DOCKETED	
Docket Number:	20-LITHIUM-01
Project Title:	Lithium Valley Commission
TN #:	247091
Document Title:	Berkeley Lab Comment on Draft Report Draft Report of the Blue Ribbon Commission on Lithium Extraction in California
Description:	N/A
Filer:	System
Organization:	Berkeley Lab/Michael Whittaker
Submitter Role:	Public Agency
Submission Date:	10/28/2022 2:28:38 PM
Docketed Date:	10/28/2022

Berkeley Lab Comment on Draft Report Draft Report of the Blue Ribbon Commission on Lithium Extraction in California

Lithium Resource Research
and Innovation Center

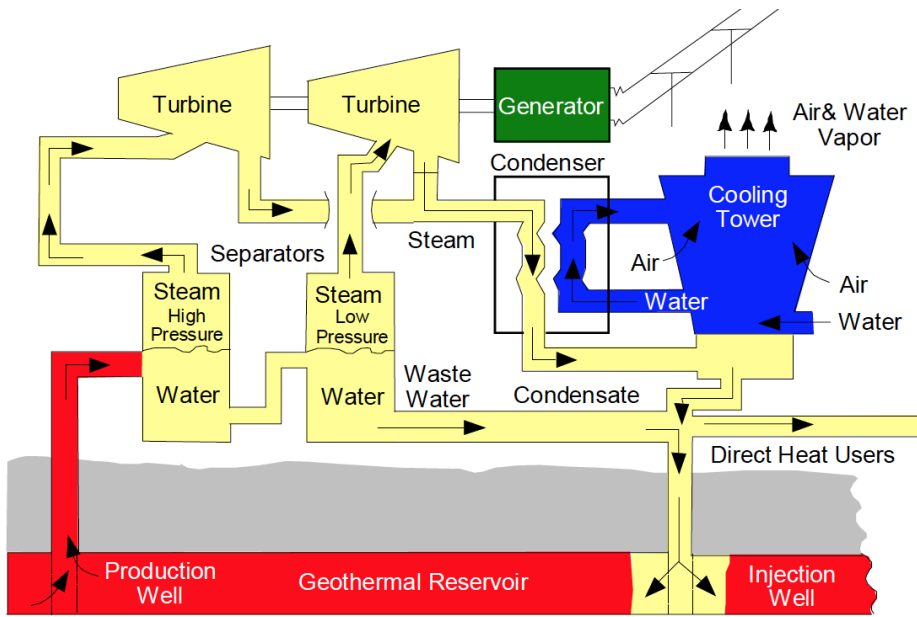
page 18 - Note that geothermal production wells at the Salton Sea are not pumped. We suggest changing the text from “As shown in Figure 7, flash steam geothermal power plants, like the geothermal power plants in the Salton Sea KGRA, use a multistep process that begins with drilling production wells deep into an underground geothermal reservoir to pump either a mixture of steam and hot brine or hot brine alone to the surface under high pressure. When the brine reaches the surface, the pressure is dropped producing steam that a turbine connected to a generator to produce electricity.” to “As shown in Figure 7, flash steam geothermal power plants, like the geothermal power plants in the Salton Sea KGRA, use a multistep process that begins with drilling production wells deep into an underground geothermal reservoir to deliver a mixture of steam and hot brine or hot brine to the surface under high pressure. When the brine reaches the surface, the pressure is dropped, producing more steam, which drives a turbine connected to a generator to produce electricity.” Below are two more accurate schematic depictions of a flash power plant akin to those found at the Salton Sea geothermal field; you might consider using one of these in place of the current Figure 7:
